AGENDA PORTLAND PLANNING BOARD MEETING

PLANNING BOARD REPORT PORTLAND, MAINE

12-Unit Affordable Housing Development
47 Boyd Street
Level III Site Plan and Subdivision Application

Submitted to: Portland Planning Board Date: November 8, 2019 Public Hearing Date: November 12, 2019	Prepared by: Caitlin Cameron, Urban Designer CBL: 022-I003 Project #: PL-000801-2019
---	--

Figure 4 Front and Side elevations

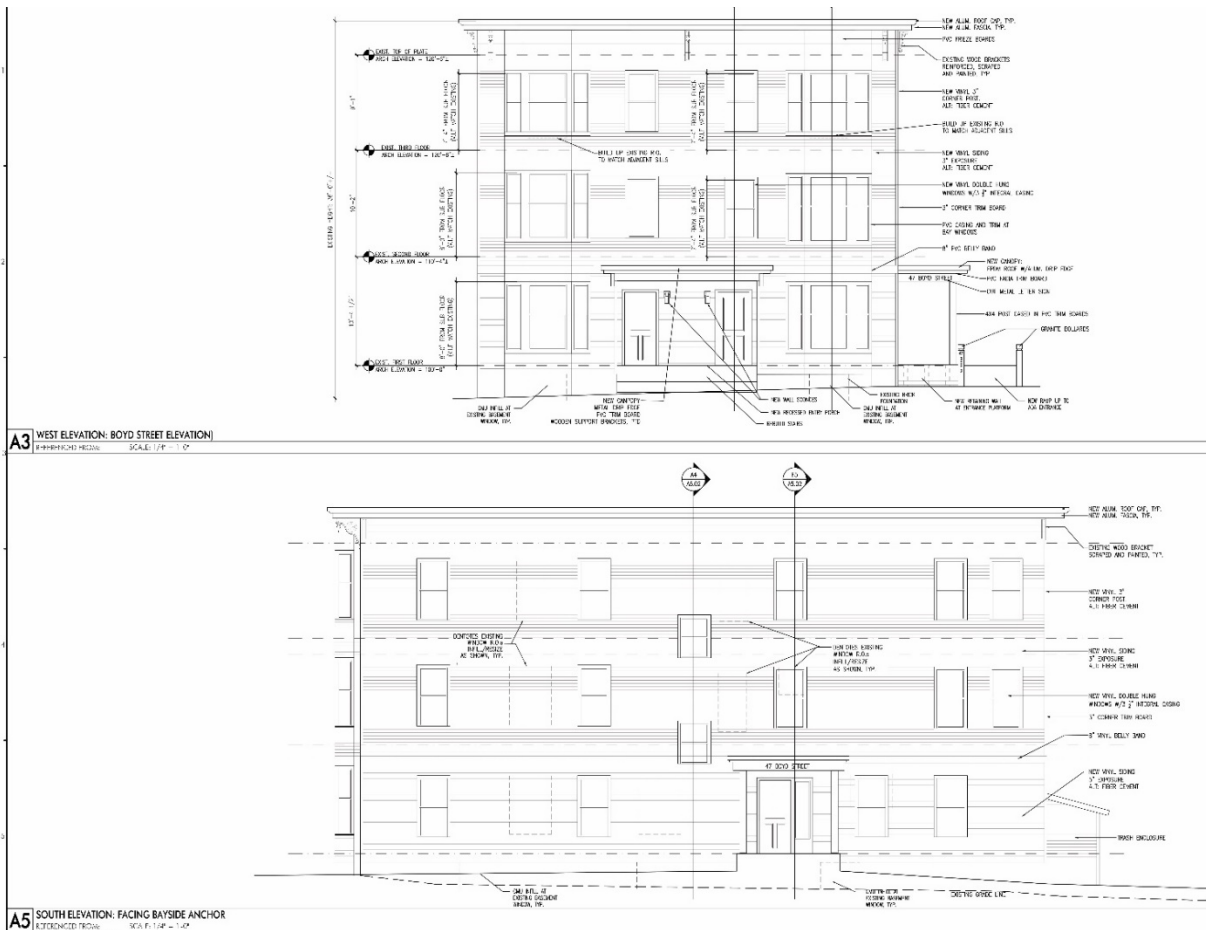
Very few exterior changes are proposed for the building. The project meets the standards of the R-7 zone for residential buildings. The building is visually interesting, includes massing variation, context appropriate materials, and the new, side-facing entrance is indicated at the street with a path, canopy, and bollards. Refer to the design review comments from the Urban Designer regarding the proposed elevations and renderings below (*Attachment 4*):

- a) Existing bays and stoop face the street – being revised to include windows.*
- b) Entrances to the ground floor units directly accessible from the street. A side entry to the upper units is side-facing in order to be ADA accessible.*
- c) The residential character of the building is being preserved and enhanced in an appropriate way.*
- d) This is an existing building that include bays, front stoops, overhanging cornice line to provide variation and articulation.*
- e) The project includes street-facing entries with stoops to engage the street. There is ample fenestration but set above the view of passersby for privacy.*
